**Performance Characteristics Subcommittee
Unapproved Meeting Minutes – Milwaukee, WI – October 24, 2012**

10.4 Performance Characteristics Subcommittee – Ed teNyenhuis, Chairman; Craig Stiegemeier, Secretary

Figure 25—Equivalent zero-phase-sequence network for transformer with two externally available neutrals and 0° phase shift between windings 1 and 2

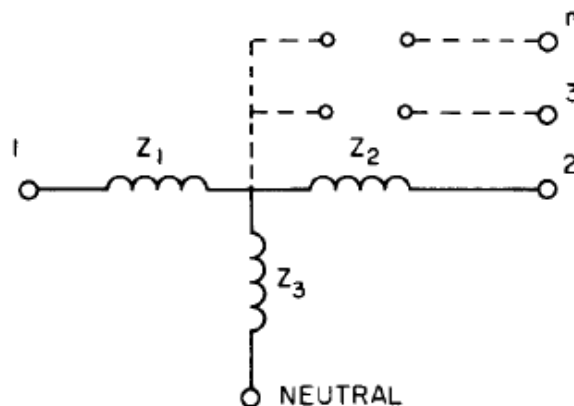
The following notes were taken during a review of the figure and suggested comments:

- Joe Foldi stated that the significance of having the user needs an accurate value of Z0 to use for fault current calculations. Under fault conditions, the core would be saturated. Dr. Ramsis Girgis responded that, under fault conditions, the core would have a higher flux density but likely would not be saturated by the leakage flux caused by the fault current. So, determining Z0 under test conditions typically used by manufacturers should be sufficiently close to the value at fault conditions. The same applies to the claim that Z0 for 5 limb cores is sufficiently close to the Z+ because core saturation under fault conditions is not a possibility.

- It was suggested to make some editing to the proposed text such that one paragraph deals with 3 phase 3 limb cores and the other with 5 limb cores. The following modified notes were developed using the recommendation in the PowerPoint presentation as a starting point:

- The statement in the proposed text regarding the possibility of tank overheating if the applied current is > 20 % of rated current needs to be examined to determine if it accurate. Also, a recommended limit based on the outcome of that investigation should be developed for the allowable current during the Z0 test..

- Dr. Ramsis Girgis stated that the reason manufacturers typically use levels between 10% and 20% of rated current for the Z0 test in a YY with no Delta designs is that the Z0 from the individual windings to the tank is typically is in the range of 4 – 8 times the Z+.

- Note for wye-wye transformers or autotransformers without a delta tertiary: For 5 leg core form and for shell form transformers, Z3 is very large and the zero sequence impedance is equal to the positive sequence impedance levels. Z3 is very large and the zero sequence impedance is equal to the positive sequence impedance for 5 leg core form and for shell form

- For three leg core form transformers, the Z3 value is typically 5-10 times the Z12 measured value due to the "phantom delta" effect of the tank and/or tank wall shielding. The Z3 value should be taken into account in short circuit calculations involving the zero sequence impedance. Measurements should be made at different current levels to establish the non-linear curve for all four different measurements. Care should be exercised in performing this test and the current should usually not be more than 20% of nominal since the return flux from the core goes through the tank wall or tank wall shielding and can cause severe overheating at higher current levels
